The Evolution is Complete – The Aprilaire Upgraded Air Cleaner Line Now Offers A Better Solution for More Customers

Media COMPARISON

201 Media versus 213 Media

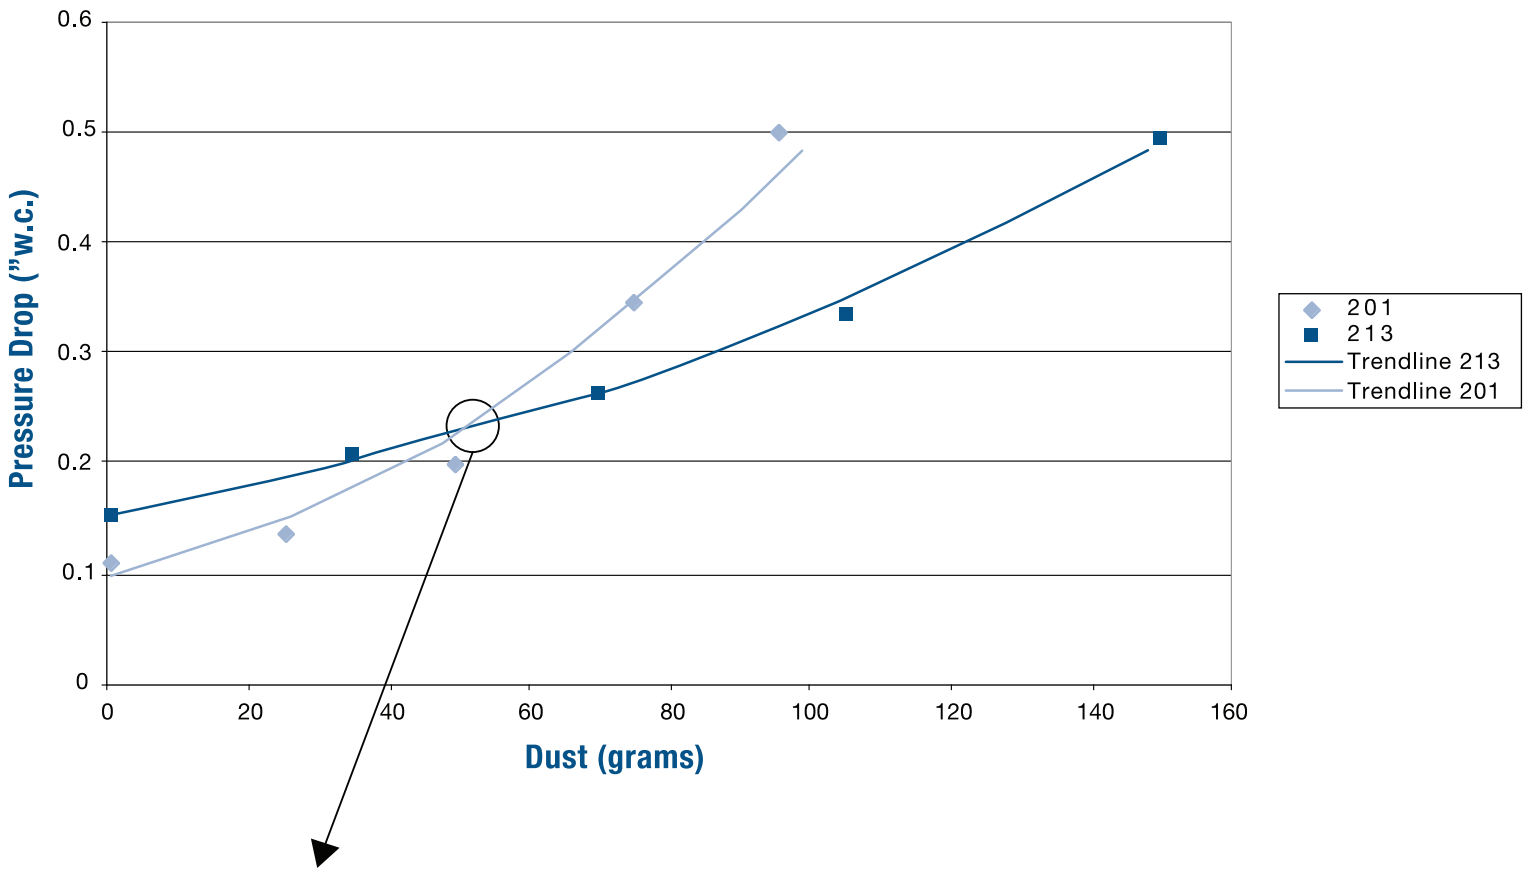
Under 50 grams of dust load the pressure drop of the 2200 and 4200 are equal. (50 grams of dust loading is about 1/2 the filter life on both the 2200 and 4200). If the 2200 has not been a problem at 50% of its life, the 4200 will not either as the 4200 performs better for the remaining 50% of filter life.
